Title - Sujet CCTV FOR CBSA LACOLLE	
Solicitation No. - N° de l'invitation 47446-166562/A	Amendment No. - N° modif. 001
Client Reference No. - N° de référence du client 47446-166562	Date 2015-12-04
GETS Reference No. - N° de référence de SEAG PW-\$\$HN-324-68337	
File No. - N° de dossier hn324.47446-166562	CCC No./N° CCC - FMS No./N° VME
Solicitation Closes - L'invitation prend fin at - à 02:00 PM on - le 2015-12-22	Time Zone Fuseau horaire Eastern Standard Time EST
F.O.B. - F.A.B. Plant-Usine: <input type="checkbox"/> Destination: <input checked="" type="checkbox"/> Other-Autre: <input type="checkbox"/>	
Address Enquiries to: - Adresser toutes questions à: Theriault, Joelle	Buyer Id - Id de l'acheteur hn324
Telephone No. - N° de téléphone (819) 956-3484 ()	FAX No. - N° de FAX (819) 953-4944
Destination - of Goods, Services, and Construction: Destination - des biens, services et construction:

Amendment 001 is issued to provide Questions and Answers and to extend the solicitation close date.

Plans ML-1 6092424- 662960 represent the current situation. The only difference is the location of the manhole.

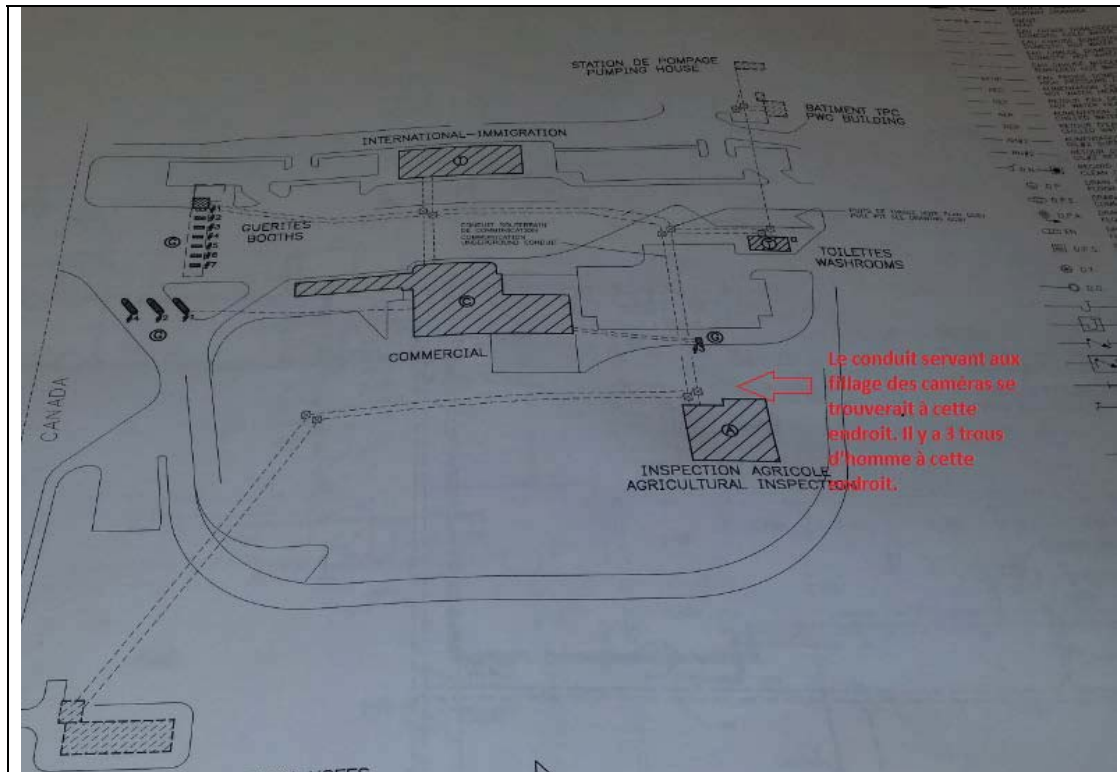
Image translation: The conduit containing the camera wiring would be found at this location. There are three manholes at this location.
